SUBJECT: Triangle Expressway Southeast Extension (Complete 540) from NC 55 Bypass in Apex to US 64/264 (I-87) in Knightdale, Wake and Johnston Counties; Federal Aid No. STP-0540(19), STP-0540(20), and STP-0540(21); WBS Nos. 37673.1.TA1, 35516.1.TA1, and 35517.1.TA1; STIP Project Nos. R-2721, R-2828, and R-2829

Also, please reference your November 25, 2025 email, requesting modification of the permit to authorize change of impacts at Permit Sites 14, 15, and 31, for R-2829B. The modifications at 14 and 15 are necessary for an alternate Neuse River bridge design that reduces the overall length of the bridge by 290 feet, saves approximately \$2 million in construction costs, reduces bridge construction time by 23 weeks (including short term impacts to the river and the Neuse River Greenway), and reduces required concrete truck trips by 262 loads.

The Corps has completed the evaluation of your request and has determined that it is appropriate and reasonable, and that no public notice is required for this modification. Therefore, the permit is modified as requested and as shown on the enclosed R-2829B Mod Permit Drawings, Sheets 1, 30-39, 76, and 110-112, submitted November 25, 2025.

PHASE I:

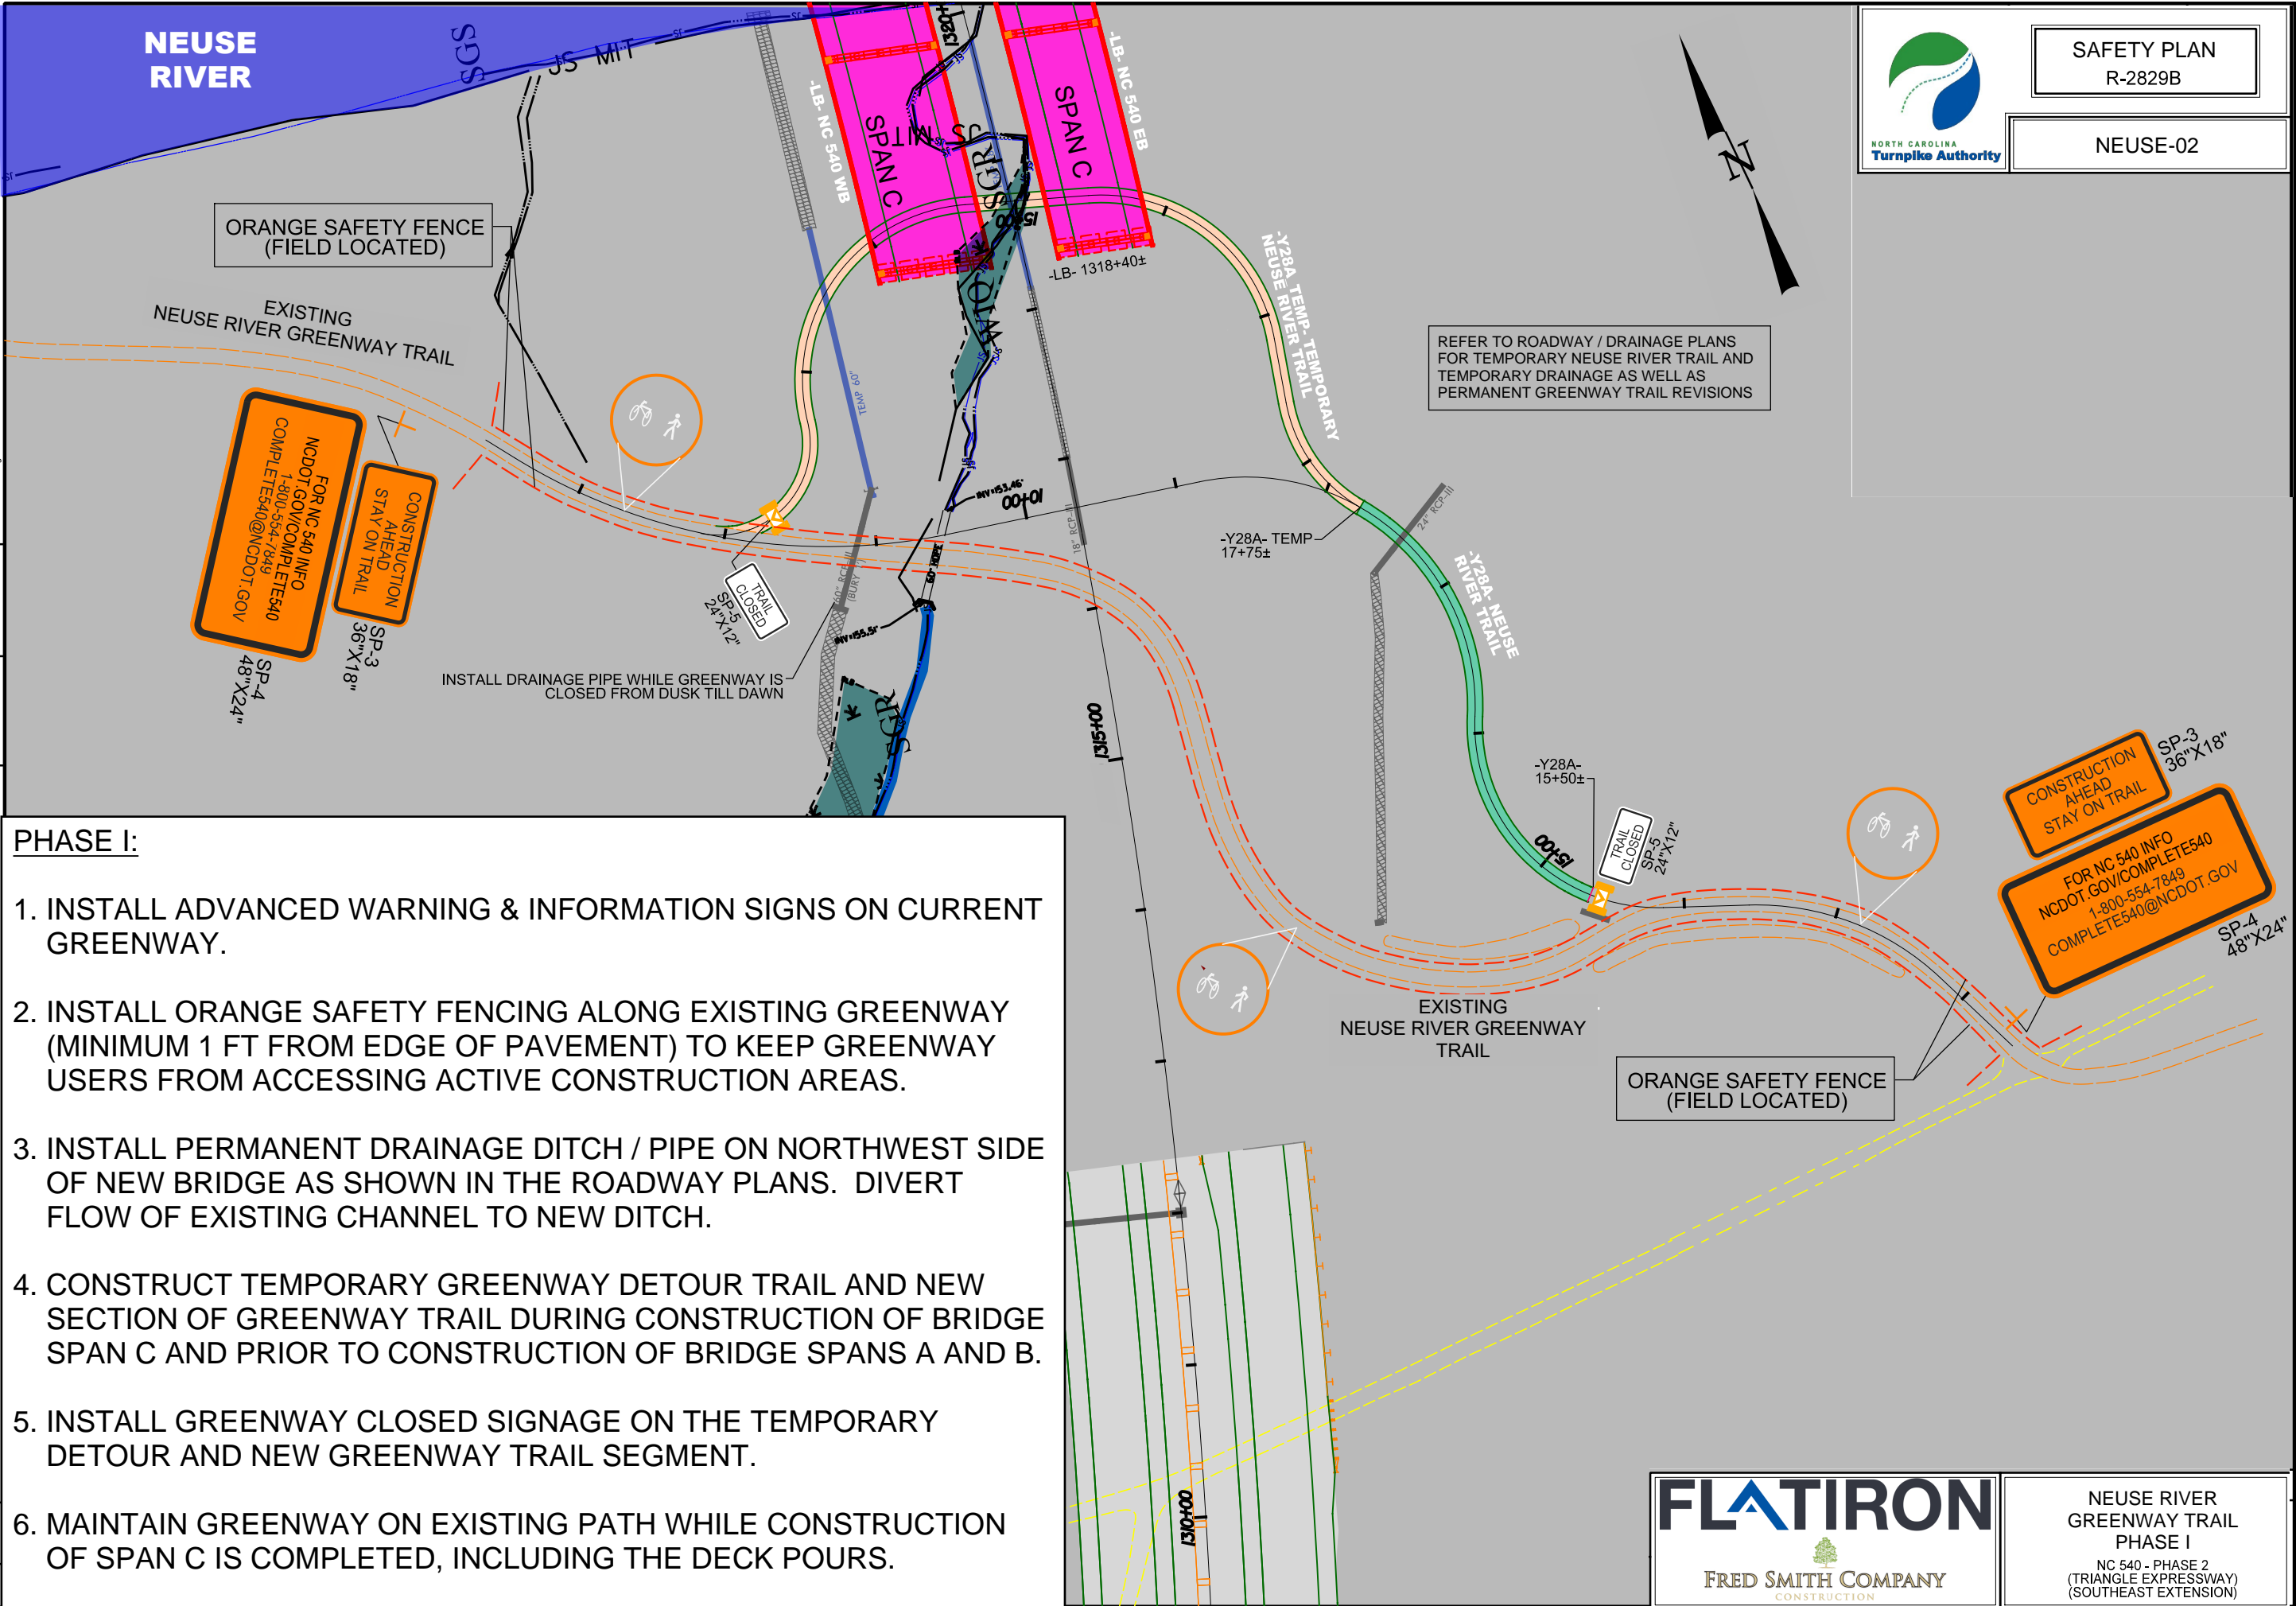
NO.	DATE	DESCRIPTION	REVISOR	CHECKED BY
1	6-16-25	Y28 & Y28A NEUSE RIVER GREENWAY TRAIL ALIGNMENTS REVISED	CEO	GMK
2	7-21-25	Y28A & Y28A TEMP NEUSE RIVER GREENWAY TRAIL ALIGNMENTS REVISED	KRG	GMK
